## **Subject area A: Accuracy and appropriateness of groundwater category maps**

### **Para 44: Issue: Definition of Category A boundaries is flawed**

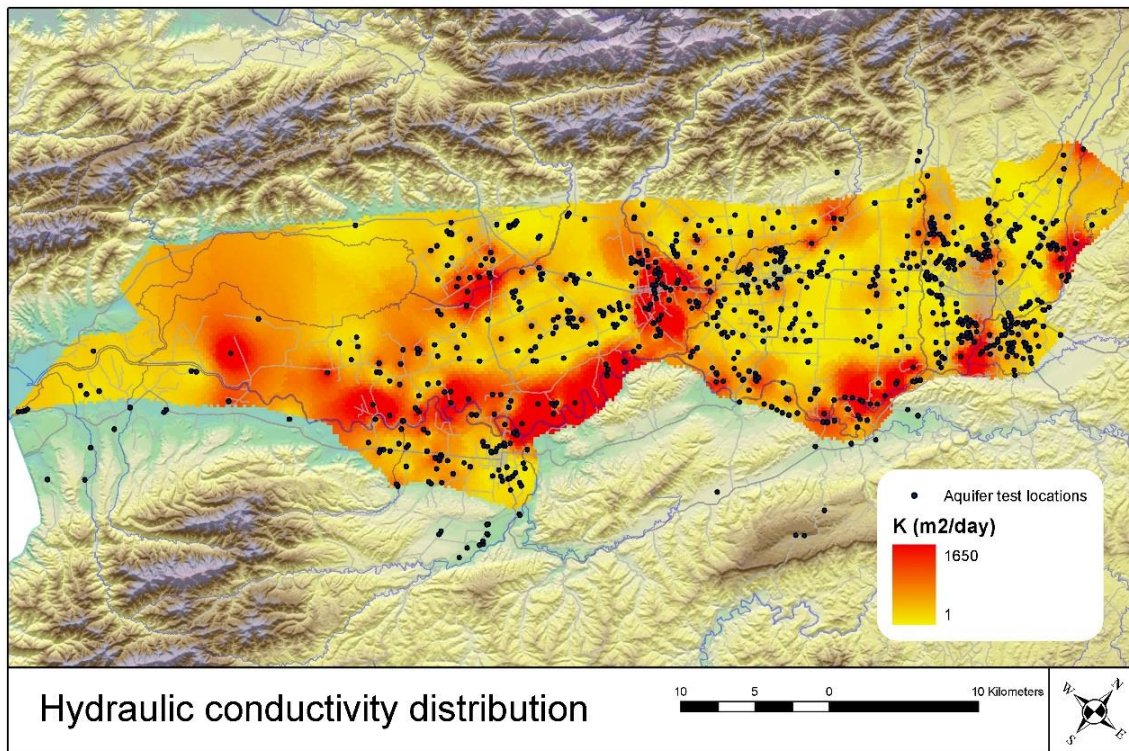
1. Para 44 (JW): Basis for the definition of Category A boundaries was largely based on the spatial extent of Q1 alluvium deposits. He considers this extremely inaccurate.

3. The map below (taken from Jones and Gyopari, 2006) shows that, on a valley-wide scale, the highest permeability ('K') areas, shown in red, are restricted to areas mapped as Q1 alluvium – this is especially evident along the Ruamahanga flats, the Waiohine Plains, Tauherenikau River and in the Te Ore Ore area.
